REFERENCE:	Nova Bus Manuals
SECTION:	02: Doors
RS N°:	MQR 7621-2345

APPLICATION DEADLINE: 2023JU01
CLAIM REFERENCE NUMBER: WB-5261

SUBJECT:	Doors
JUSTIFICATION:	Door code 105 is being logged on electric doors

Figure 1 - Connect the Laptop, Validate the Programm Version

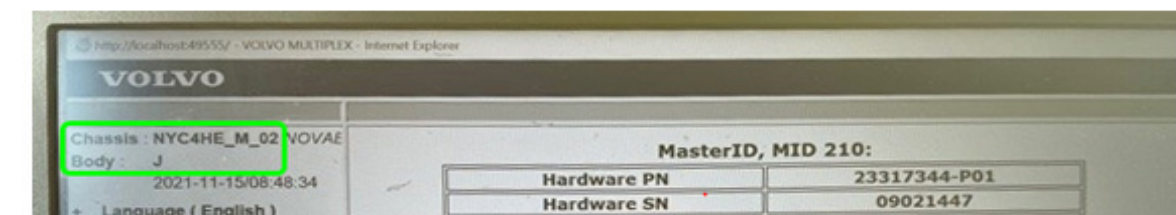
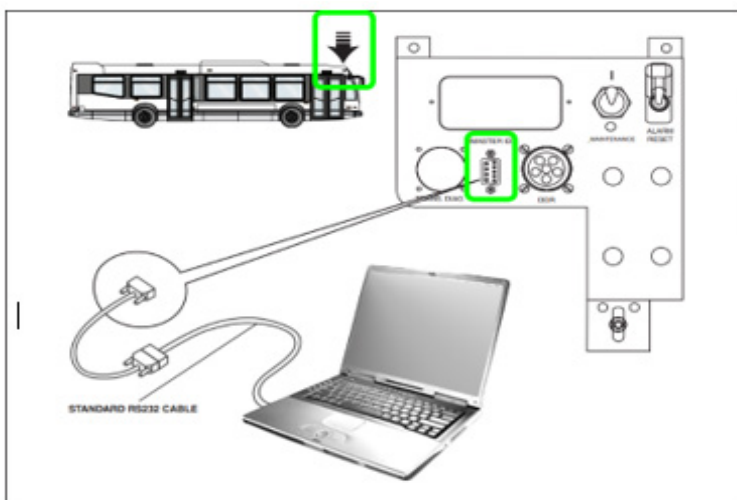
- 1.3. Vapor Bus team will need to reprogram the VBI vDEC module with V3.05.14 (VBI campaign).
- 1.4. Follow the following steps to reprogram the Nova VBEA multiplex system software with the following or more recent program version: **FB_NYC4DE_M_05 rev. D**.

- 1.8. Check if the appropriate FB software package version and revision information is displayed as follows by the Volvo application software to confirm that the VBEA multiplex system software was properly updated.
